Access Compliance Report

Public Rights-of-Way

Intersection ID: 2729	Main Street: FAIRVISTA_DR	Cross Street: FAIRWAY_POINT_DR	Location: NE
ADA ID: 56558AC0A301	Ramp Type: PerpDiag	Initial Pass/Fail: Fail	Overall Compliance: No
			Severity Score: 21.25

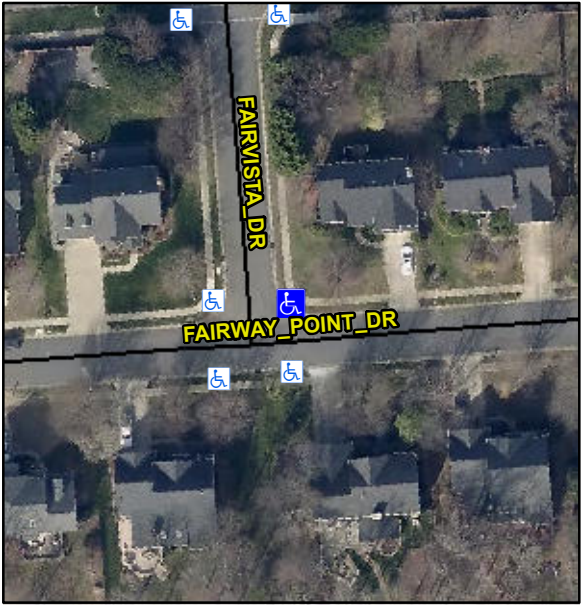
Codes/Mitigation Info/Possible Solution		Field Measurements/Component Compliance					
	Possible Solutions:	Compliance	Description	Data	Compliance	Description	Data
	Remove & Replace Curb Ramp With Two New Directional Ramps or Equivalent.	N/A	Ramp Length (in)	46.0	Yes	Ramp Slope (%)	6.9
		No	Ramp Width (in)	40.0	No	Ramp XSlope (%)	5.5
		N/A	Flare Type LT	N/A	N/A	Flare Type RT	N/A
		N/A	Flare Slope LT (%)	N/A	N/A	Flare Slope RT (%)	N/A
		N/A	Flare Traversable LT?	N/A	N/A	Flare Traversable RT?	N/A
		N/A	Landing Length (in)	N/A	N/A	DWS Provided?	N/A
		N/A	Landing Width (in)	N/A	N/A	DWS Contrast?	N/A
		N/A	Landing Slope (%)	N/A	N/A	DWS Length (in)	N/A
		N/A	Landing X Slope (%)	N/A	N/A	DWS Full Width?	N/A
		N/A	Landing Curb? (Y/N)	N/A	N/A	DWS Offset (in)	N/A
		N/A	Shared Landing?	N/A			
		N/A	Gutter Ponding?	N/A	N/A	Gutter Slope (%)	N/A
		N/A	Gutter Lip Ht (in)	N/A	N/A	Gutter X Slope (%)	N/A
		N/A	Painted X Walk1?	No	N/A	Painted X Walk2?	No

X Walk 1 Direction	To W		X Walk 2 Direction	To S
		N/A	X Walk 1 Width (in)	N/A	N/A	X Walk 2 Width (in)	N/A
			X Walk 1 Slope (%)	3.9		X Walk 2 Slope (%)	2.6
			X Walk 1 X Slope (%)	1.5		X Walk 2 X Slope (%)	2.9
		N/A	Ramp inside XWalk1?	N/A	N/A	Ramp inside XWalk2?	N/A
<p>Surveyor Notes:</p> <p>N/A</p>			Road Slope (%)	4.5	N/A	Clear Space?	N/A
			Road X Slope (%)	3.5	N/A	Clear Space to XWalk (in)	N/A
<p>PROW/ADA:</p> <p>Not Found, R304.5.1, R304.5.3</p>		N/A	Any Obstructions?	N/A	N/A	Storm Grate/Utility Hazard?	N/A
			Obstruction Type			Storm Grate/Utility Type	
					N/A		N/A
					Yes	Surface Condition? (G/P)	Good
